Rezoning Transportation Analysis

Petition Number: 2022-133

Revision Log:	Date	Description		
	1-25-23	First Review (TM)		
	2-22-23	Second Review (TM)		
	04-26-23	Third Review (TM)

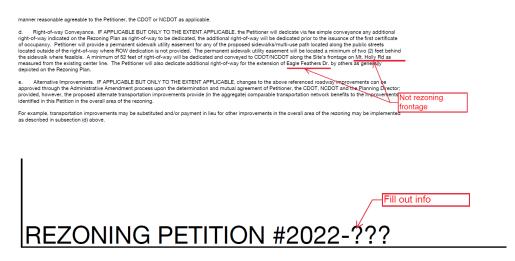
Staff will receive the petition and begin review, but the public hearing will not be scheduled until the TIS is approved to allow for the minimum time necessary for CDOT to review the study and reach agreement with the petitioner on the required transportation commitments. <u>Any agreed upon</u> commitments shall be included on the last site plan submitted no fewer than 4 weeks prior to the public <u>hearing</u>. Therefore, additional traffic mitigation comments may be forthcoming once the TIS is approved by CDOT (and NCDOT).

New Comment 04-26-2023: Site plan updates changed access location impacting both the TIS and the recommended improvements. Update or addendum to TIS required along with updated conditional notes to match TIS improvements.

Update: TIS was approved by CDOT on 1/20/2023 and NCDOT on 1/19/2023.
